Bill Hoblitzell and Kristin Thomas
262 Taylor St, Minturn, CO 81645
Nov 1, 2023

To:
Minturn Town Council
Minturn Planning and Zoning Committee
Minturn Town Staff

Re: Minturn North Final Plat Issues; pedestrian connector easement width is unsafe

Figure below from Final Plat documents shows proposed 4' trail easement for pedestrian connector ways between streets in Minturn North. This design is substandard to Minturn code even for downtown sidewalks and insufficient and unsafe for two-way traffic that includes bicycles.

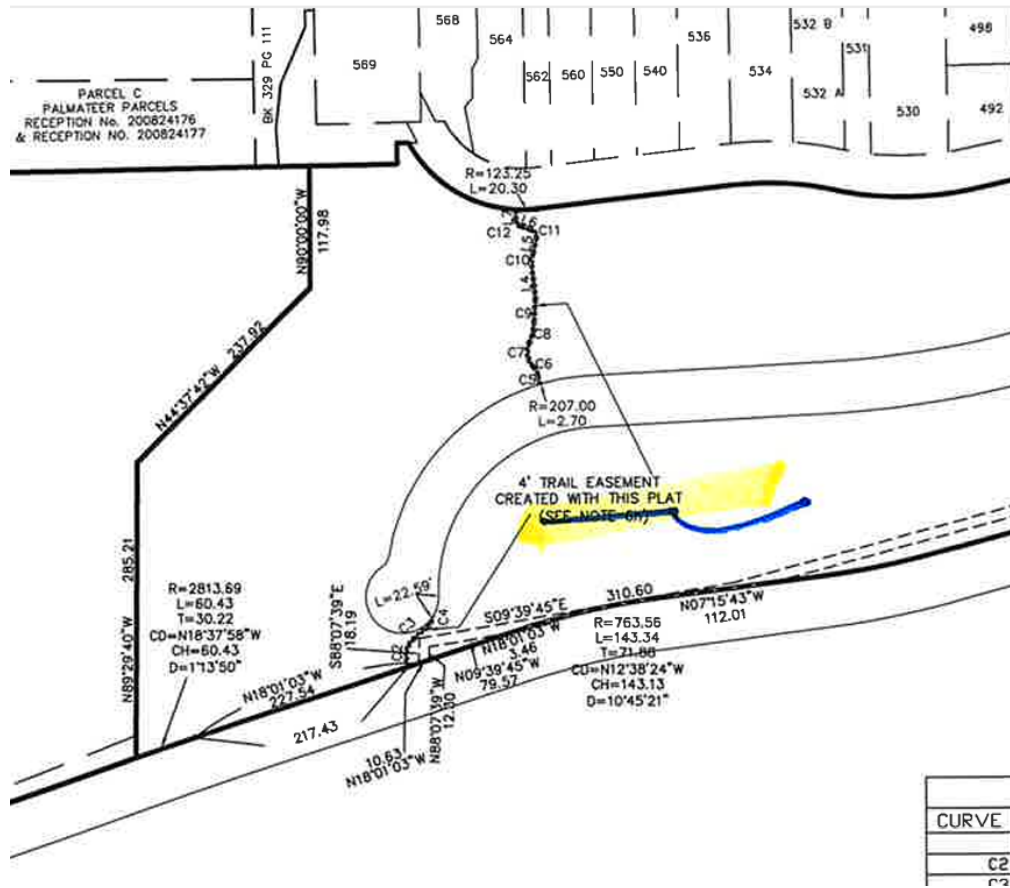
We are requesting that you review and request staff and developer to amend the proposed pedestrian connector path easement/ROW width in Final Plat document design and increase the easement width from the substandard and unsafe 4' it is currently shown at to a minimum of 8' prior to approval. **The design as-proposed does not currently meet with either quantitative or qualitative sidewalk criteria identified elsewhere in Minturn's municipal code, is inappropriate and unsafe for the intended uses, and should be modified accordingly before final plat approval.**

The Minturn North pedestrian connections to Taylor Street and EcoTrail/Minturn Road in the final plat diagrams that have been provided online identify a trail easement or right of way of only 4 feet. These connectors are intended to accommodate 2-way traffic of bikes, pedestrians, strollers, and pets. This width is insufficient and inadequate for safe for these uses. The specified trail easement and right of way should be, at a barest minimum, 6-7', and preferably 8-10', consistent with contemporary designs in our peer communities.

Average modern bike handlebar width is 750mm to 800 mm, or around 30 inches. Most walking and jogging child strollers are approximately 25 inches, or slightly over 2 feet. For these to even successfully pass each other with 1' clearance without physical contact, a bare minimum of 6-7' is needed.

We sincerely hope we will not make yet another one on this issue. Please remedy the pedestrian connection easements and widths to 8-10', equal to or better than the designs of the same infrastructure in our peer communities. Why should Minturn yet again be content to build its community infrastructure to a lesser standard than any other?
